Canon F-1

CANON SERVICE MANUAL

Canon SERVICE MANUAL REPORT

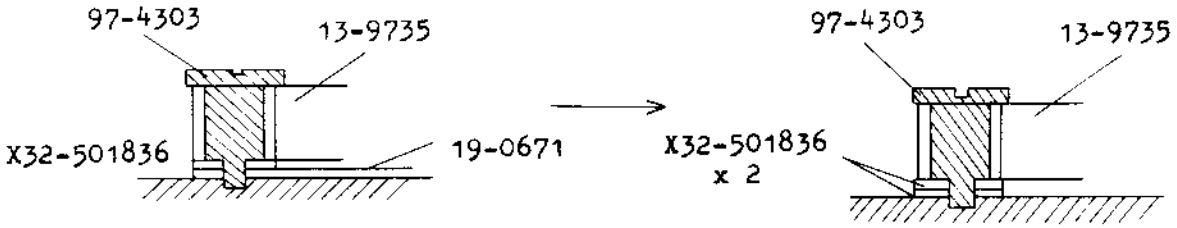
A second washer has been added under the brake band to replace the deleted portion of Brake Band Base(19-0671).

Old and new parts are not interchangeable. Camera Service will stock only new bodies, but will stock both new parts and old parts including special service parts which are shown below. Brake Band(13-9735) for use with old cameras is available with two different end radii. (15R and 18R). The 18R band is correct for most cameras.

1st Curtain Brake Assembly

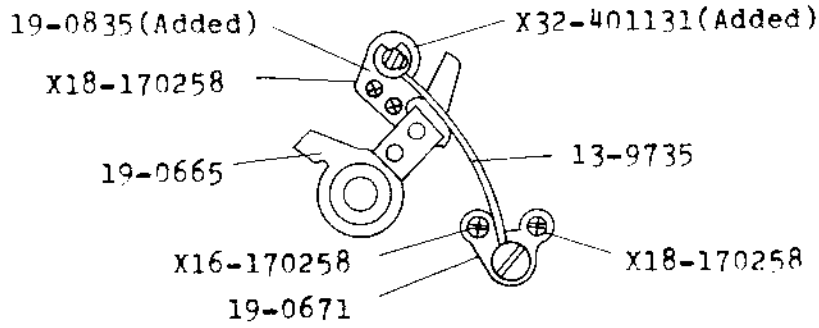
Certain changes to prevent 1st Curtain bounce were reported in SMR AC30-010 E. Further improvements have been made by increasing the 1st Curtain Brake stroke and making both ends of the brake band adjustable with eccentric screws.

Several parts have been changed to lengthen the brake stroke. They were changed as shown below.

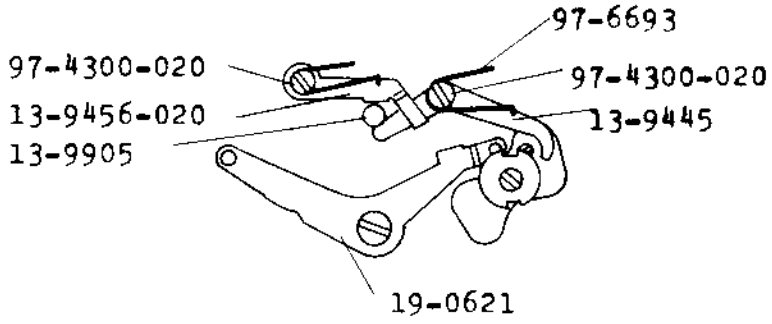
Note: As a result of this change, an important operational change must also be made. For double exposure, the rewind button is only returned 1/2 turn rather than 7/8 turn with the old system. Cameras with the new system have a GREEN rewind button instead of the old RED button.

Adjustment: The rewind button is now released by 19-0621 pushing 13-9456-02. Release should occure at 70 to 90° of the winding stroke. Adjustment is made by choosing the correct 13-9456-02 from the 3 sizes available.

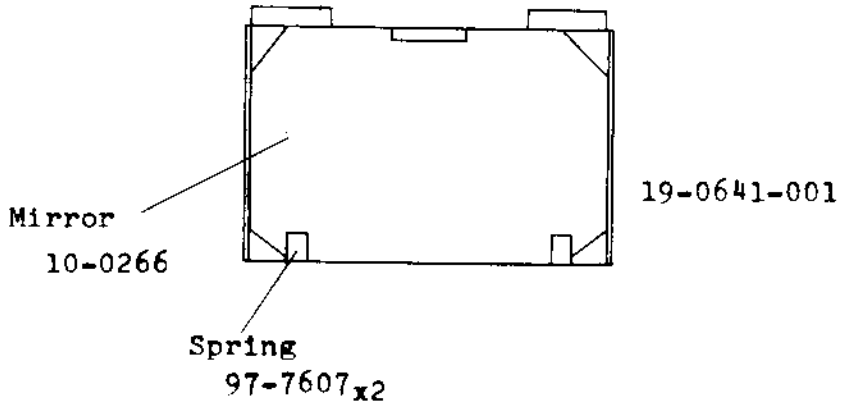
Mirror(10-0266) and Spring(97-7607) are now available as separate parts so the mirror can be replaced without removing the mirror box as is necessary when the Mirror Unit(19-0641-001) is replaced.

1. Apply a small amount of solvent(ME Ketone) to the two Springs (97-7607) and remove them.
2. Put solvent between the mirror and mirror base and remove the mirror.
3. Clean the mirror base with solvent.

Note: Don't remove the protective tape from the mirror.
1. Apply plyobond to the mirror base as shown.
2. Carefully slip the mirror under the spring at the back of the mirror base.
3. Apply Diabond to the springs and slip them into place.
4. Remove protective tape from the mirror and check the mirror.

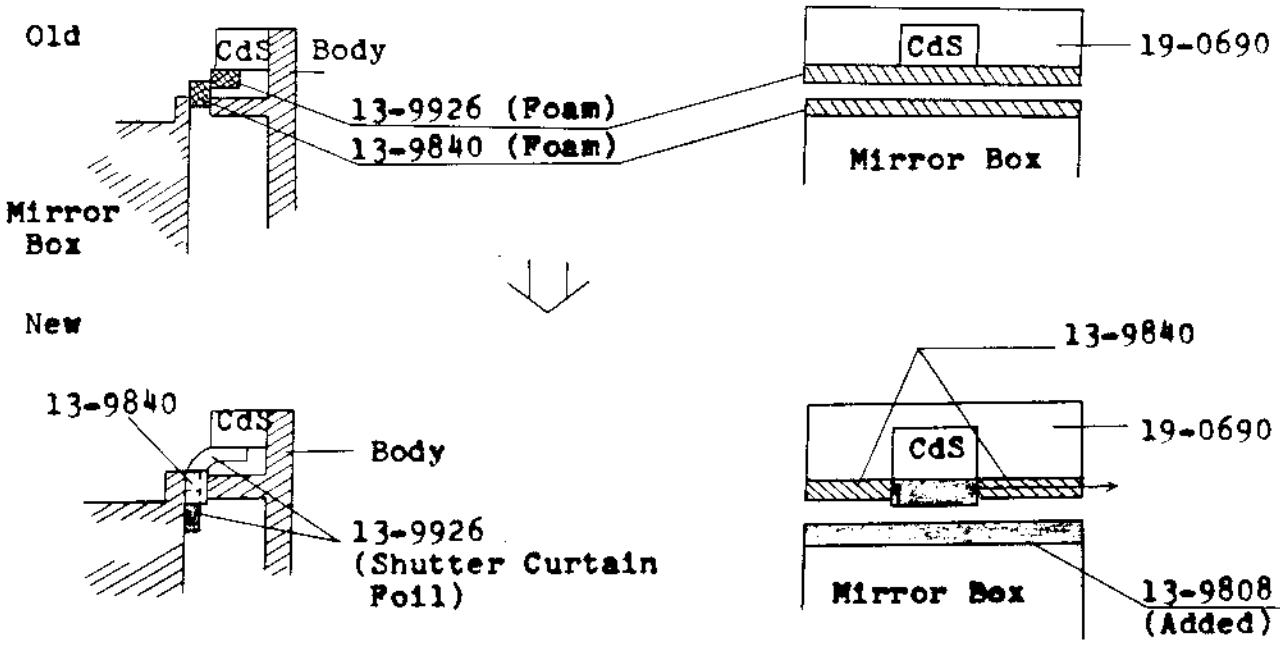
Now the piece between the body and mirror is made from F-1 shutter curtain material. The single piece of foam under the CdS Case has been replaced by 3 pieces. A piece of foam is used under each end of the case and a piece of shutter curtain is used directly under the CdS. This piece also curves down between the body and the mirror box.

13-9926 - Foam Light Shield changed to Shutter Curtain 5mm x 21mm
13-9840 - Foam Light Shield (46.5mm) changed to 15.5mm x 2.
13-9808 - Light Shield (Shutter Curtain) Added

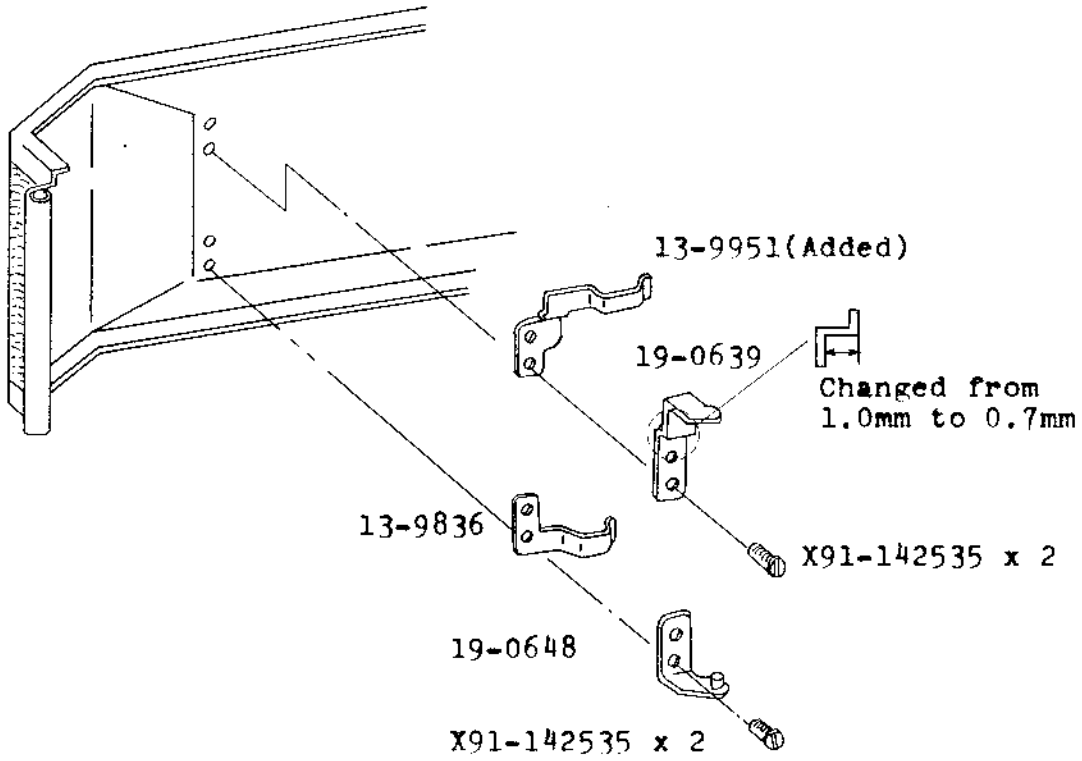
Another Film Pressure Spring(13-9951) has been added to hold the film against the upper sprocket, in addition to the lower Film Pressure Spring(13-9836).

The new spring mounts at the same position as Roller Holder (19-0639) so the offset part of the holder has been reduced from 1.0mm to 0.7mm.

The new parts can be added to any F-1. Both must be added if either one is added. These parts and the larger roller(SMR AC30-026E) should be added to any camera with film overlap problems. Spool Torque is not changed.

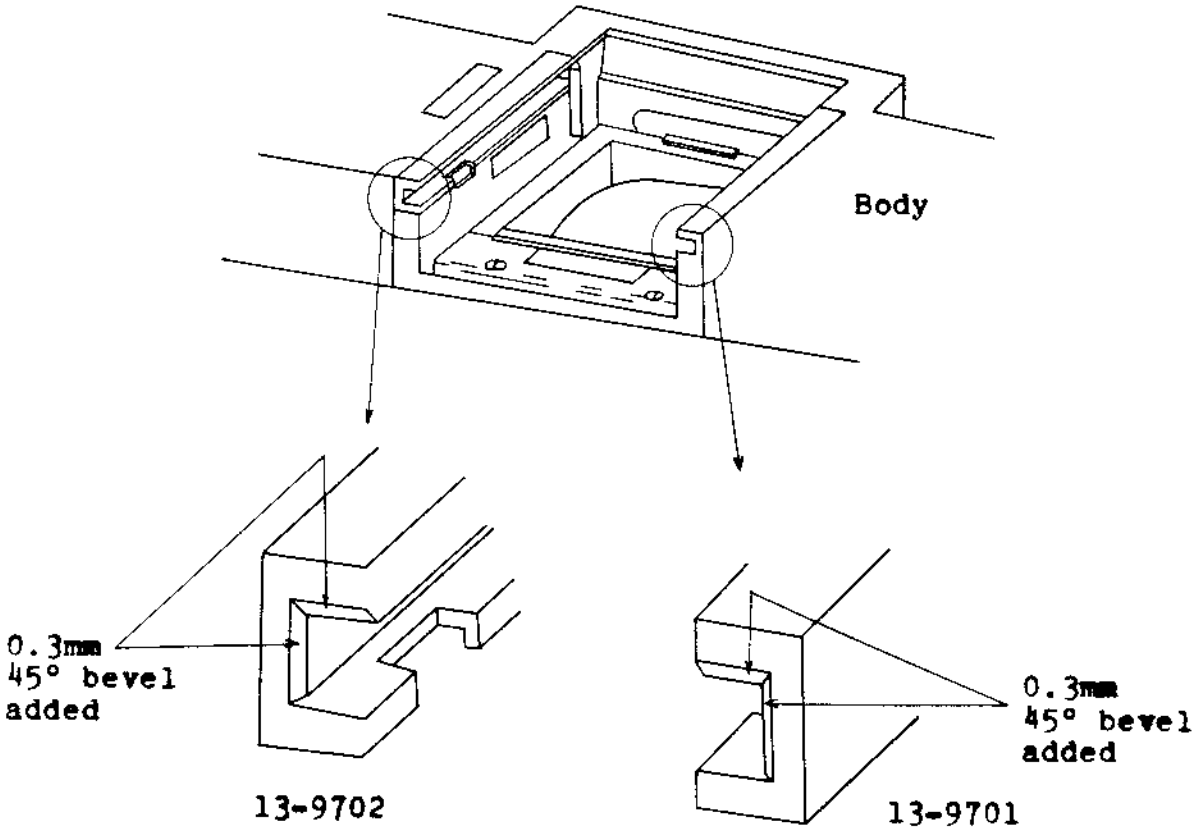
To prevent this problem, a 0.3mm, 45° bevel has been added to both pentaprism rails.

Old and new parts are interchangeable. Both rails should be changed if either one is changed. Camera Service will stock new parts only.

Mirror Clamp Lever
(19-0645)

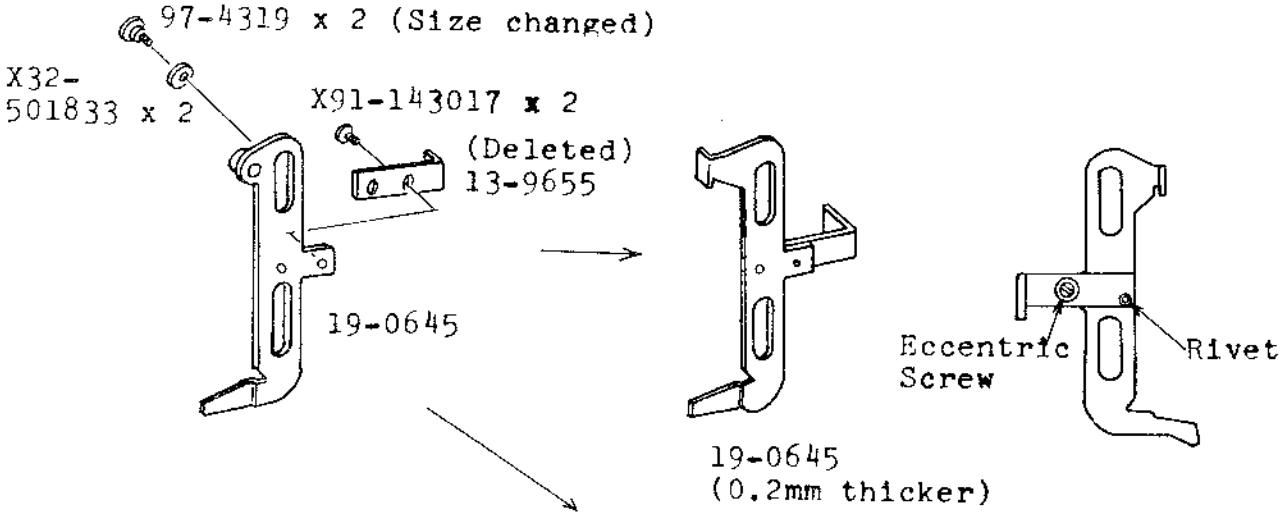
The correct method for locking the mirror up is to first press the stop down lever and set the lock lever to "M". If the lock lever is set to "M" without first pressing the stop down lever, the two Diaphragm Closing Levers (19-0643,19-0644) sometimes stick. To prevent this, they have been changed.

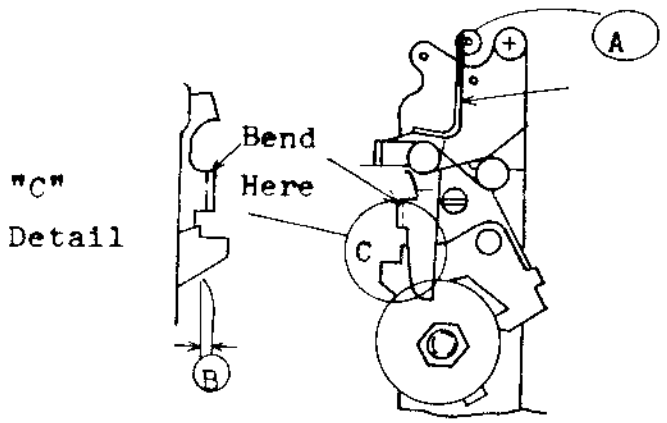
Old self timer can normally be adjusted to work by bending the tab shown toward the self timer.(This reduces the "B" dimension shown in the partial drawing.)

It is not reccomended to bend the top of the lever "A". This normally provides a temporary repair only.

Repair Manual, pg. 4

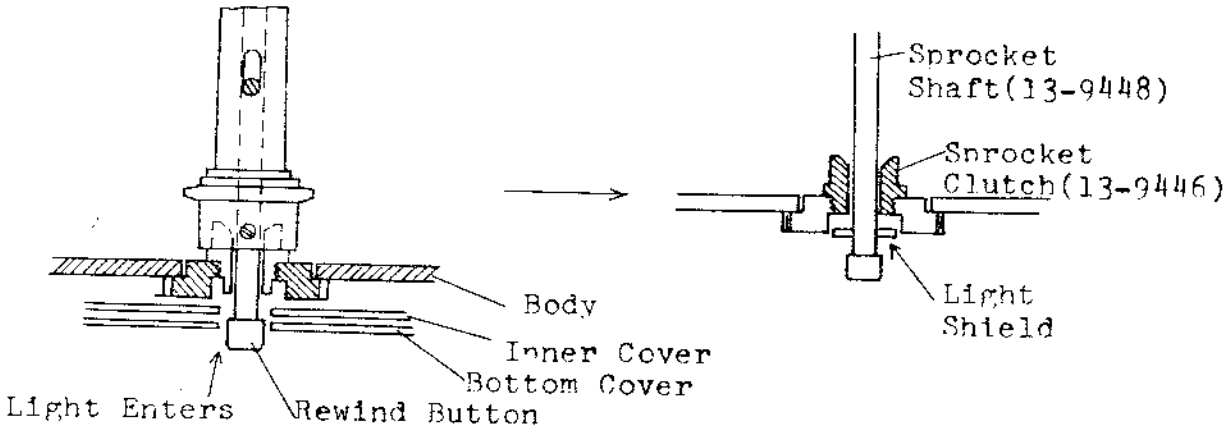
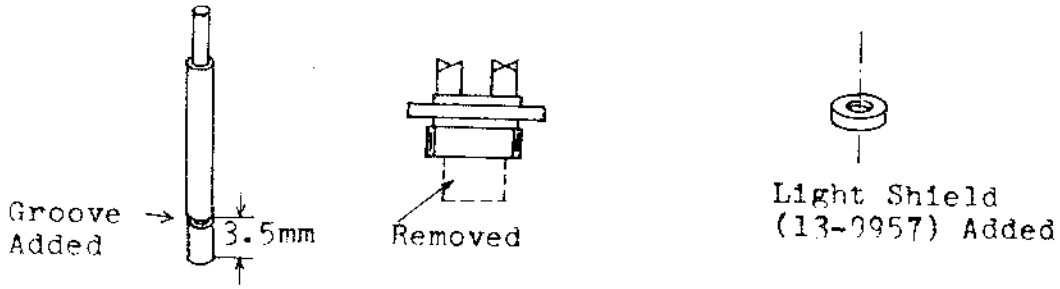
To prevent possible light leak around the rewind button thru the middle of the sprocket and out around the screw slot in the sprocket, a Light Shield Collar(13-9957) has been added to the Sprocket Shaft(13-9448).

If this problem occures, change 13-9446, 13-9448 and add 13-9957. The old 13-9448 cannot be used.
Camera Service will stock new parts only.

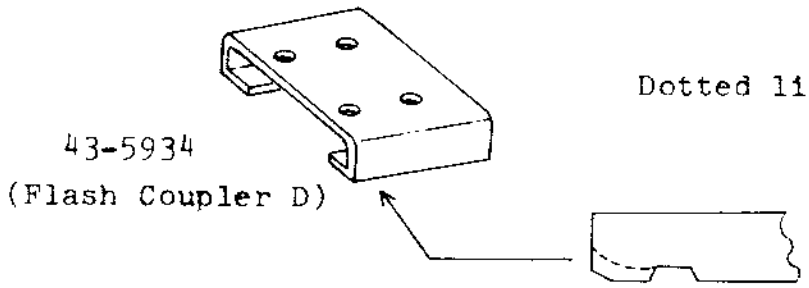
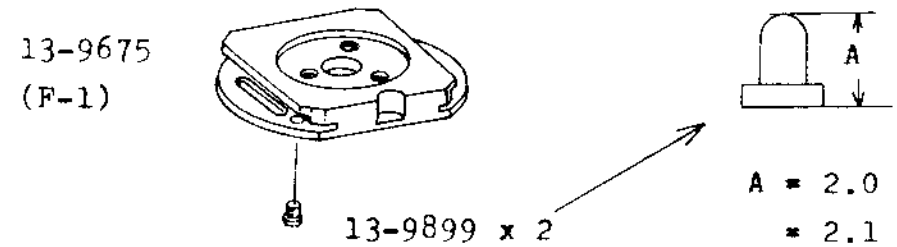
The click lock on some early Flash Coupler D's does not hold the coupler securely enough. The Flash Coupler D Foot (43-5934) has been changed to make the click lock more positive.

Click Pin(13-9899) x 2 which were a part of Accessory Shoe (13-9675) are now separate service parts and available in 3 different lengths to adjust the strength of the click lock.

If a customer has this problem with his flash coupler , change the flash coupler Shoe(43-5934) and the Click Pins. Adjust the force required to remove the coupler from the F-1 to 1.6 to 3.2 Kg by installing the correct length click pin.

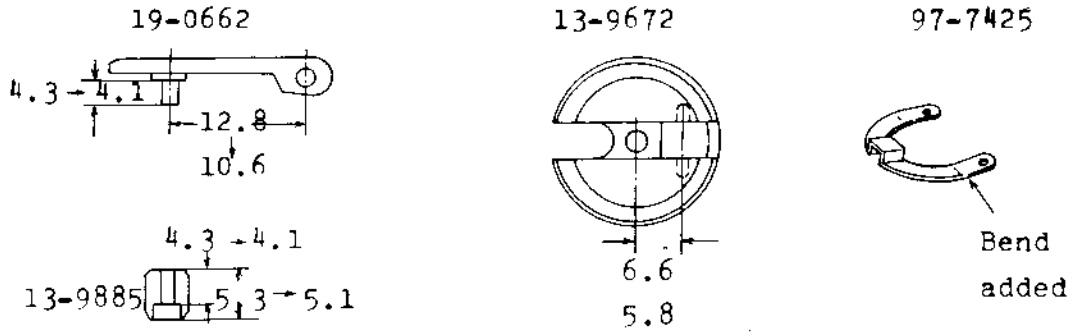
To facilitate rewinding with the Servo EE finder mounted, the changes shown in the drawings have been made to the rewind crank. These changes provide greater clearance for the fingers when rewinding.

Individual parts are not interchangeable but Rewind Crank (18-0474) is. Camera Service will stock both types until the supply of the old type is exhausted.

If a customer complains about rewind with the Servo EE finder replace the rewind crank.

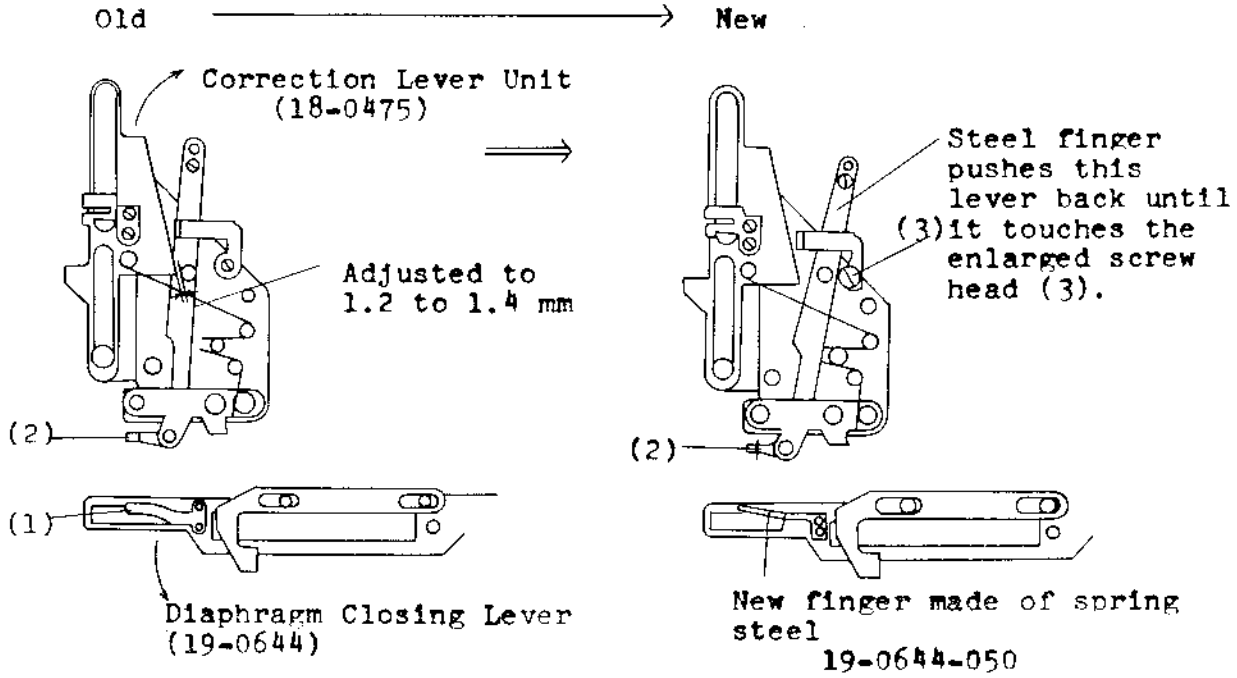
The original mechanism and adjustment of the Following Needle is shown in the left drawing. This adjustment is made to remove the following needle from the finder information window when stopped down metering is used . The finger (1) on the Diaphragm Closing Lever(19-0644) pushes against the end of the long lever and forces it back. The adjustment was made by bending the finger. Sometimes the finger will not stay bent correctly allowing the following needle to appear in the finder even when the stop down lever is pushed.

The design has been changed as shown in the right side drawing. The finger is now made from spring steel and no adjustment is necessary. Excess rearward movement is prevented by the larger screw head holding the retaining clip.

In an old camera if 18-0475 is replaced, replace 19-0644 with 19-0644-050 also. If only 19-0644 must be replaced, replace it with an identical part.

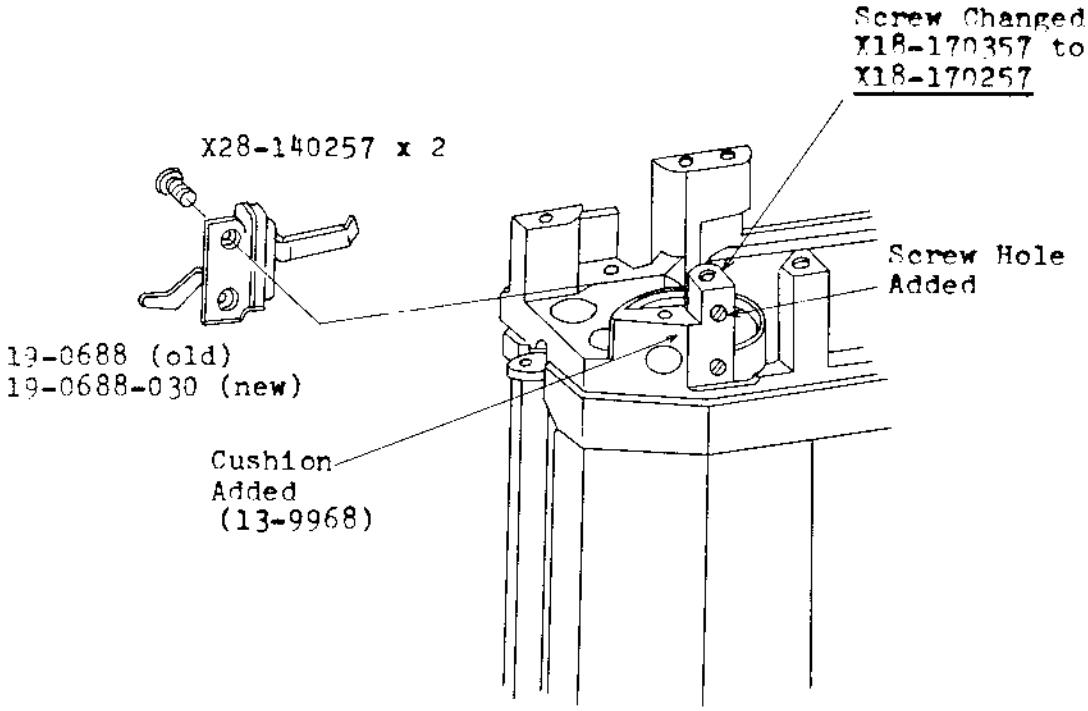
Flash Change Contact(19-0688) was originally a part of Winding-Counter Unit(18-0476) and attached to Film Counter Base(19-0615).

To improve production efficiency the mounting position of the flash(syncro) change contact has been moved to the body.

The mounting holes for the contact have been deleted from Film Counter Base(19-0615).

One of the mounting screws for 19-0615 is now shorter so it does not interfere with the flash change contact screw.

Cushion(13-9968) has been added to prevent the contact from chattering.

Old and new parts are not interchangeable. Both old and new parts will be stocked.
If syncro problems are present, add the cushion. The cushion can be added to older cameras.

New Brake Assembly Exploded View

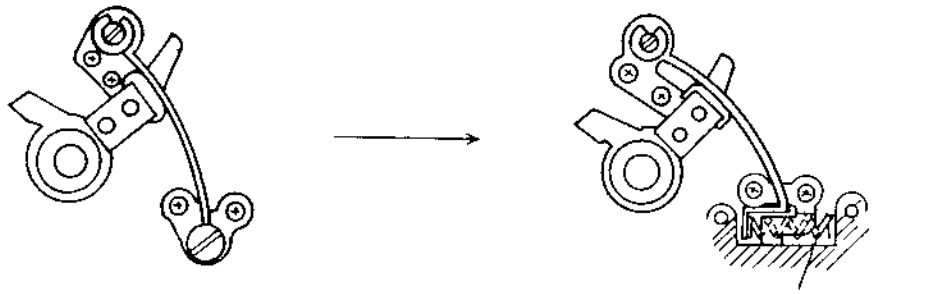
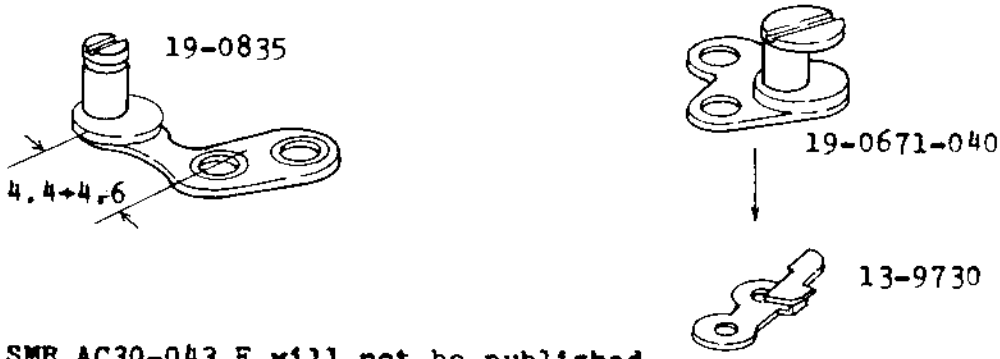
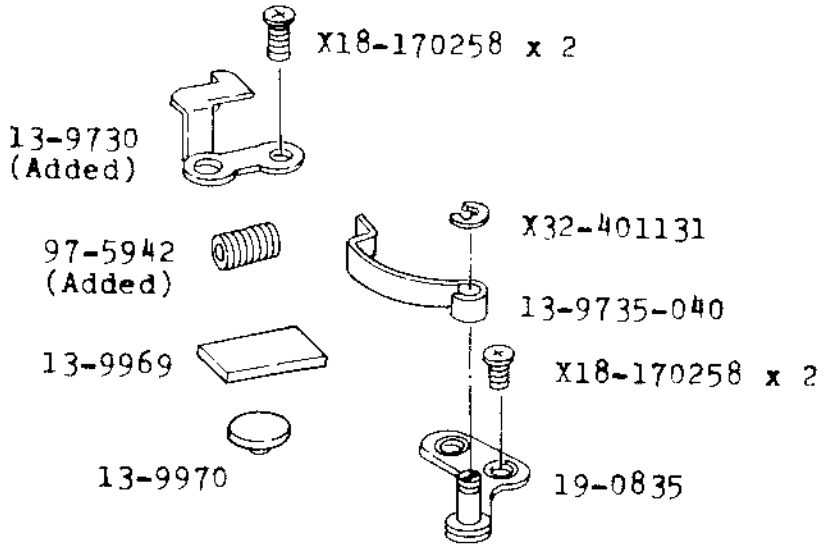
A coil spring has been added at one end of the brake band to insure constant contact between the brake and the brake band.

Bodies that have the hole for adjusting the deleted dowel from inside the film chamber need Cap(13-9970) to cover the hole when the coil spring type brake is used. (Repair Manual, pg. 11)

The coil spring brake system can be added to cameras with classification numbers of 11 or higher (All cameras with Type 3 breaks). Reference SMR AC30-015E.

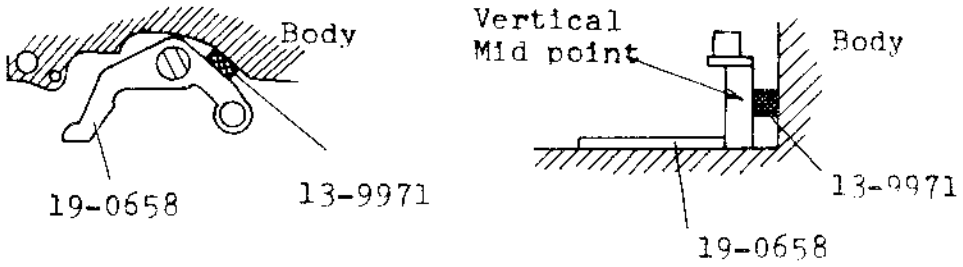
A silicon rubber pad has been added behind Brake Charge Lever(19-0658) to assist the main brake in bringing the 1st curtain to a smooth halt. Brake Leather(13-9736) is changed from suede to pig skin.

1. Place the silicon rubber between Brake Charge Lever (19-0658) and the body. Center the rubber midway of the vertical part of the lever as shown in the drawing.
